RE: St. Lucie Units 1 and 2
Docket Nos. 50-335 and 50-389
Renewed Facility Operating Licenses DPR-67 and NPF-16
License Amendment Request to Remove the Site Area Map from the Technical Specifications

Evaluation of the Proposed Changes

St. Lucie Nuclear Plant, Units 1 and 2
License Amendment Request to Remove Site Area Map from the Technical Specifications

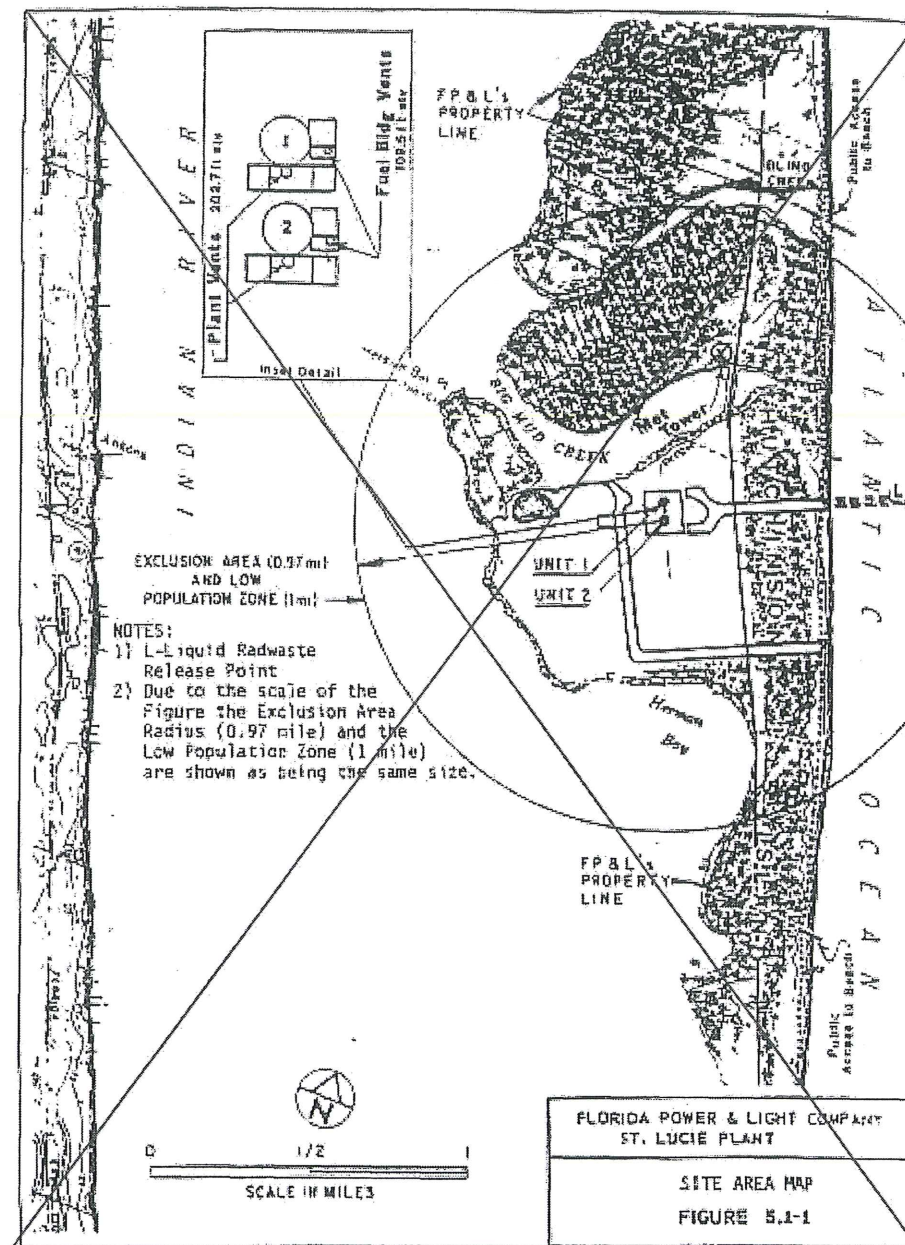
Replace with "Figure 5.1-1 Deleted"

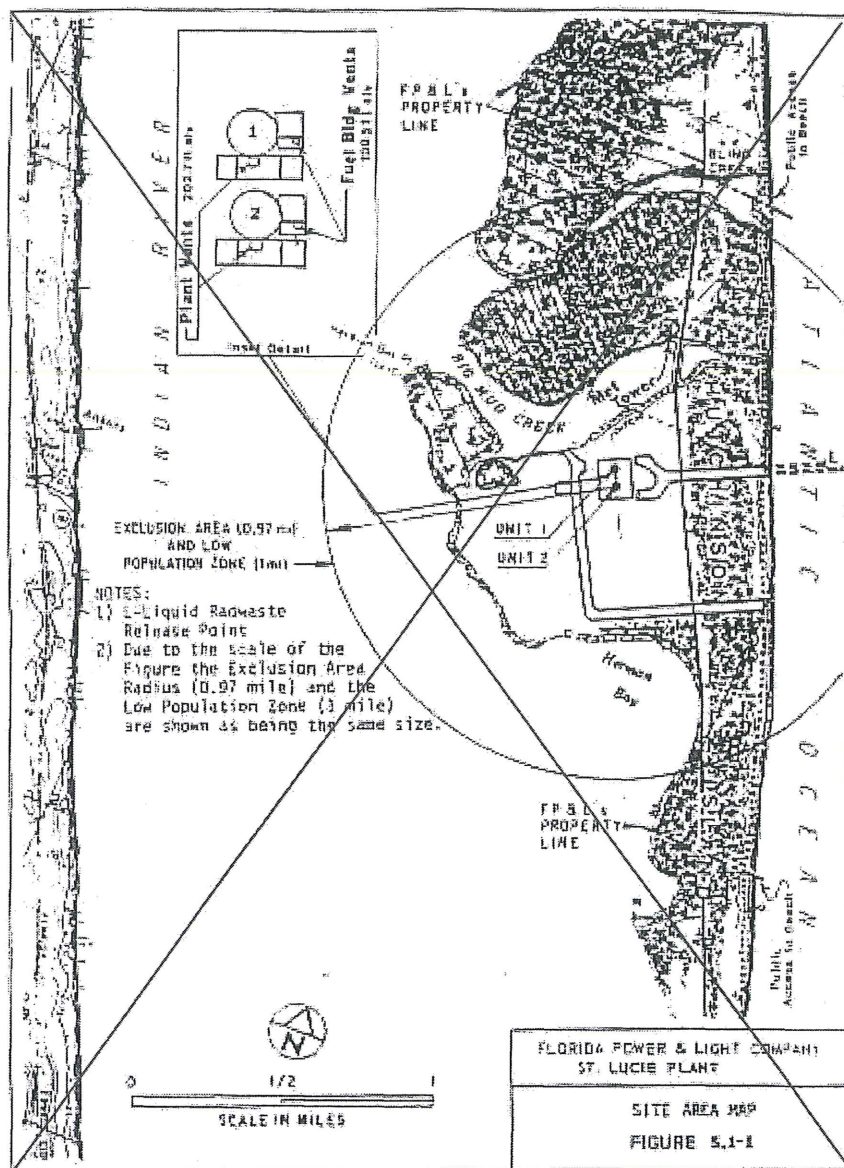
Replace with "Figure 5.1-1 Deleted"
